Location:	333 MacArthur Boulevard
Assessor's Parcel Number:	010 -0785-013-02
Proposal:	To demolish a vacant single-family home at 333 MacArthur Blvd, merge lots with the adjacent parcel at 327 MacArthur Blvd. (Temple Beth Abraham), and construct an courtyard surrounded by a sound wall for use by the Temple including an addition, retaining walls, trellises, signage, lighting, a trash enclosure, and landscaping. The Temple additionally owns other adjacent properties together comprising the center. <i>Staff has referred the item to the Board for demolition findings on the single-family home, since the merger will involve an A rated property, the Temple.</i>
Applicant / Phone Number:	Bill Coburn (510) 893-8826
Owner:	Temple Beth Abraham
Planning Permits Required:	Regular Design Review For Nonresidential Facilities and Signs; For Local Register Properties that are not Landmarks or located in the S-7 or S-20 Zone; For Potential Designated Historic Properties that are not Local Register Properties; For Retaining Walls; for demolition of any structure rated "C"

General Plan:	Urban Residential
Zoning:	RU-2 Urban Residential Zone / S-12 Residential Parking Combining Zone
Environmental Deter

SKETCH FACADE RENDERINGS OF TEMPLE BETH ABRAHAM
 STREET ELEVATION OF PLANTING &
 COURTYARD WALL

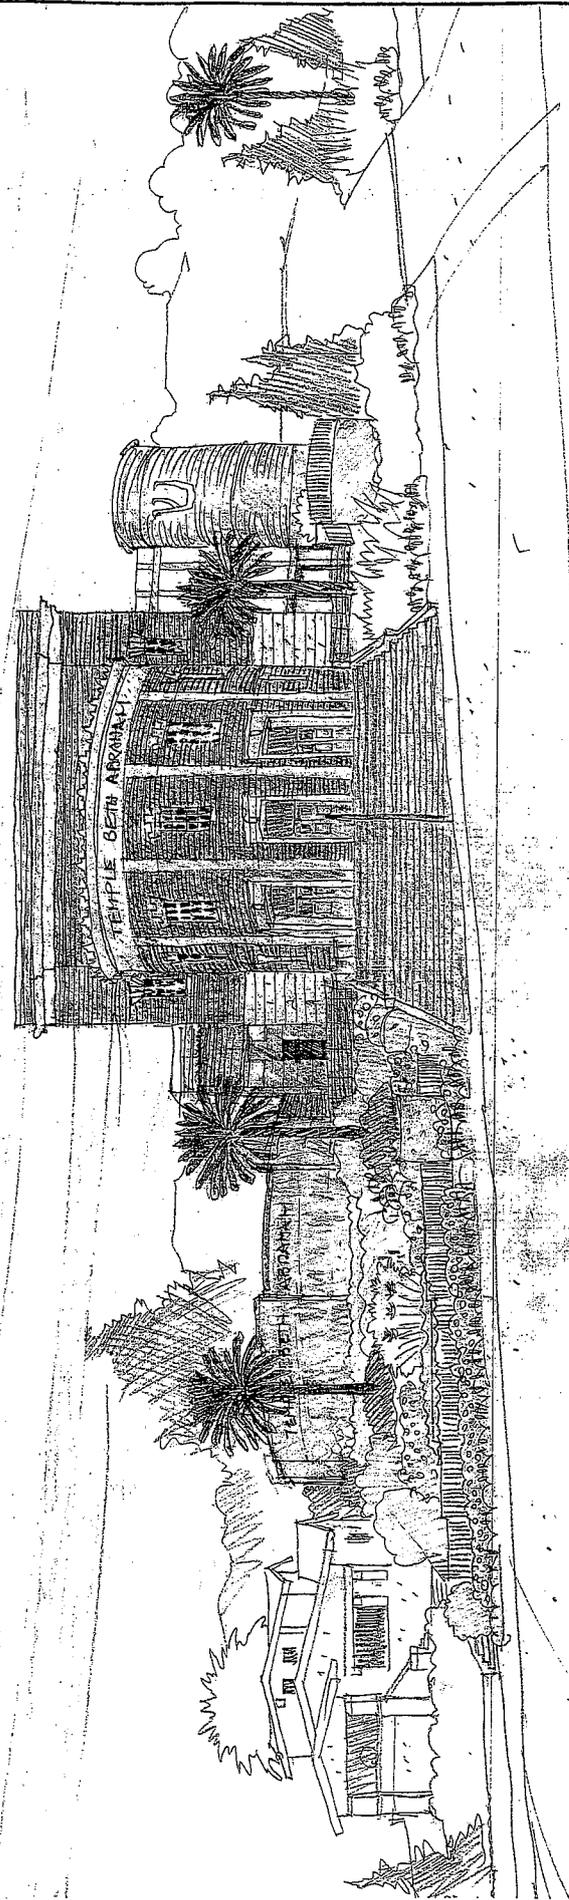
- Suggested articulation of the sound wall exterior (should the vine landscaping proposed to cover it not work, there would be some design interest to the wall);
- Suggested that the sound wall proposal be better integrated with the Temple and the recent elevator tower; look to the elevator tower for detail;
- Overall, proposal needs more detail, including specific design drawings of the trash enclosure with a roof, and the landscape palette.

- Landscaping concept has been modified to a Jerusalem (biblical) palette landscape, including date palms, four species of Middle East roses, fig and lemon trees, native myrtle hedge, lavender, native bulb;
- Modified trellis landscaping from wisteria to grape vines;
- Garden is now a walkable feature;
- Articulated sound wall on the exterior with recessed bands, reveals, separated 4' o.;
- Sound wall is a smooth finish concrete with integral color;
- Color samples and paving stone samples to be presented at LPAB meeting;
- Changed black metal to a galvanized fence to match existing fencing on the front of Temple;
- Added a sod green roof to trash enclosure to conceal open view of the individual trash cans from above.

ISOMETRIC SKETCH
 1/8" = 1'-0"

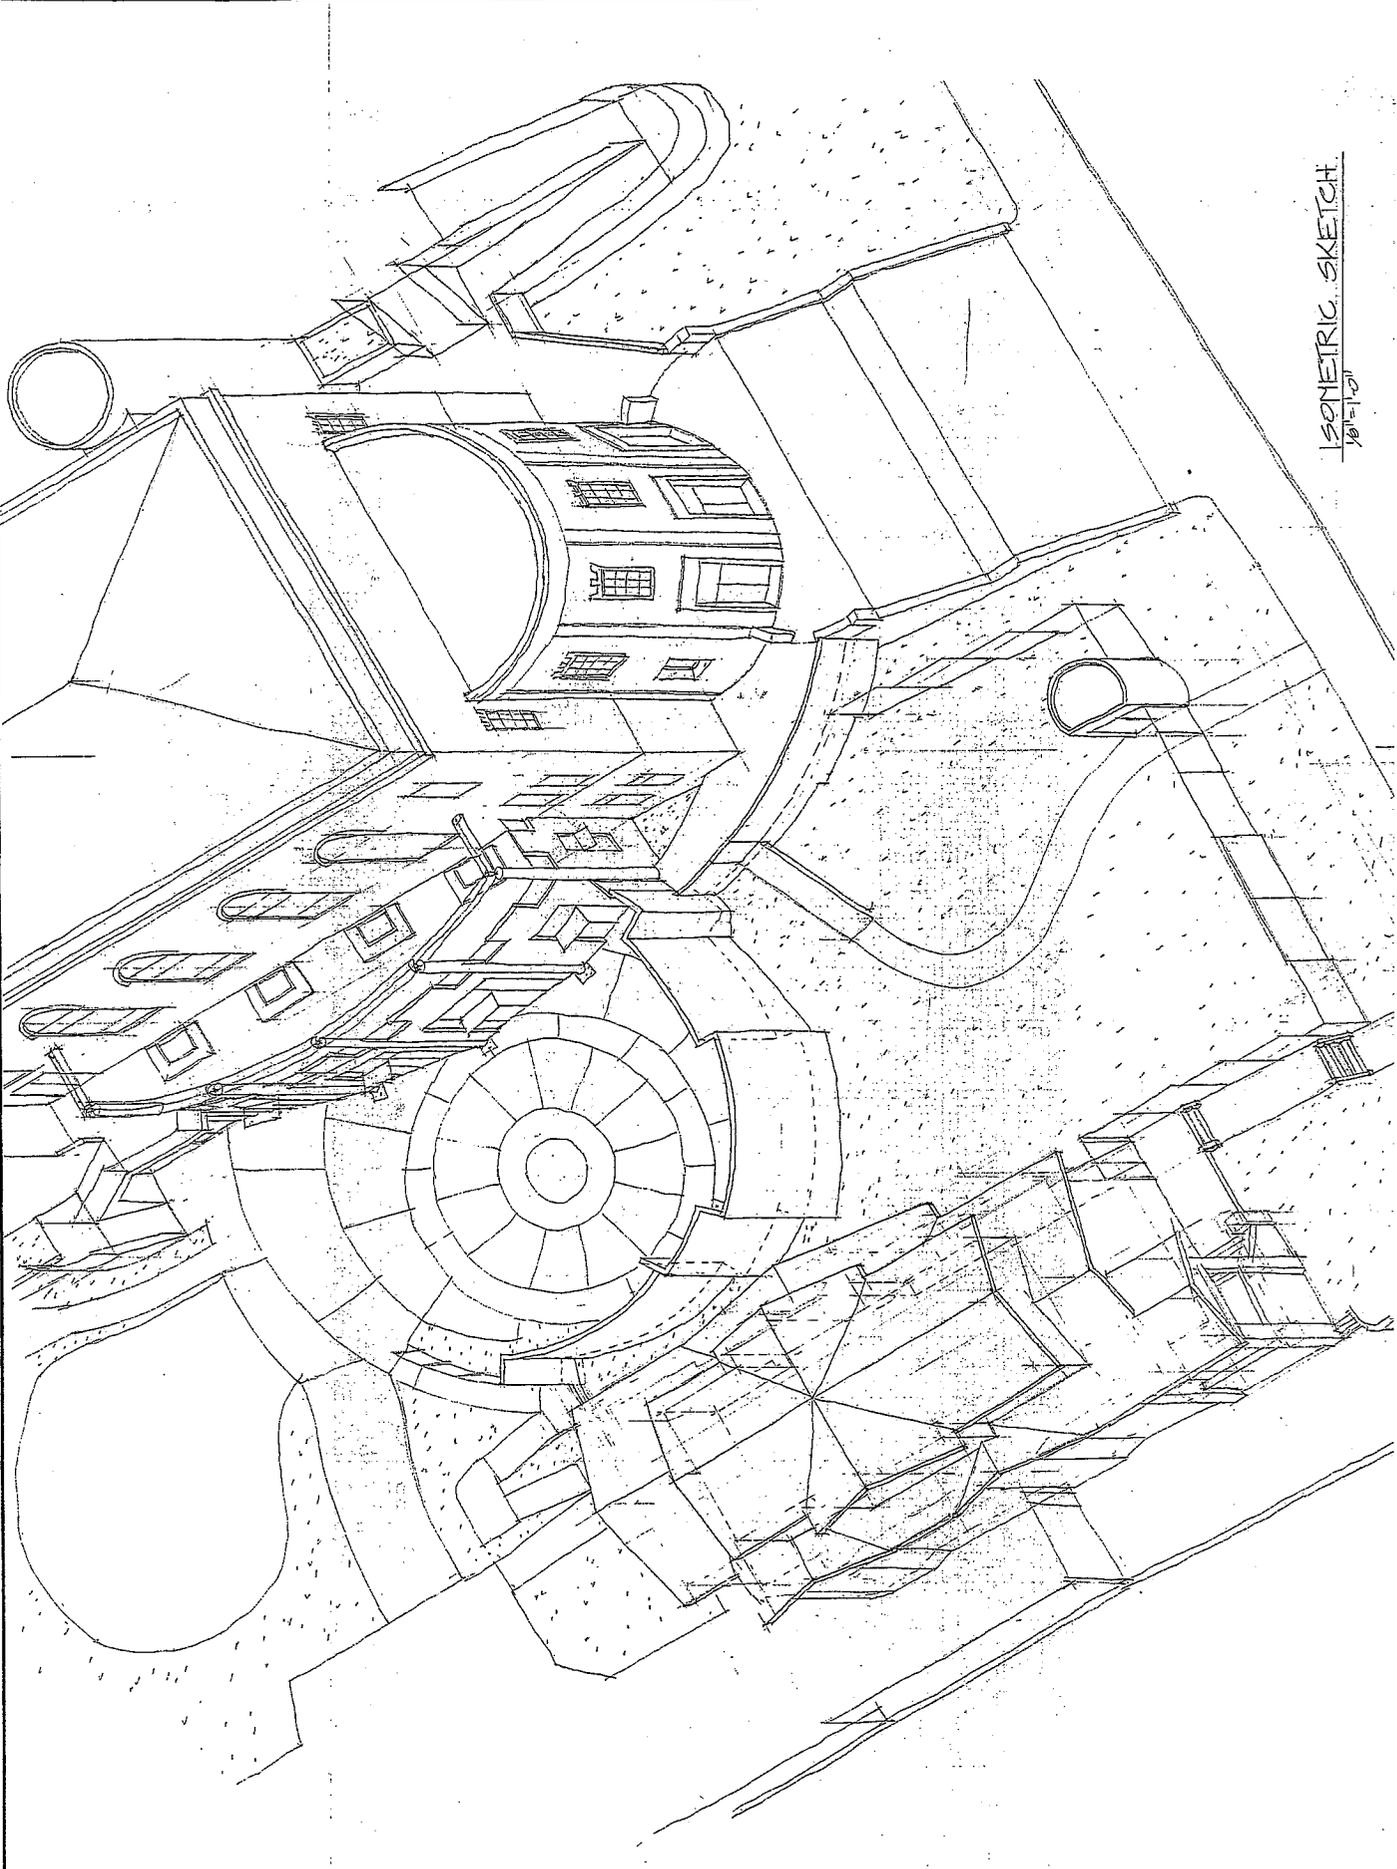
- Toured 333 MacArthur C2+ house and site;
- Requested 3-dimensional drawings to better understand proposal;
- Requested that materials be called out on the drawings;
- Requested that more landscaping be added to the parking lot and basketball areas;
- Asked about bike parking
- Overall good concept direction, but needs significant further description to fully understand proposal.
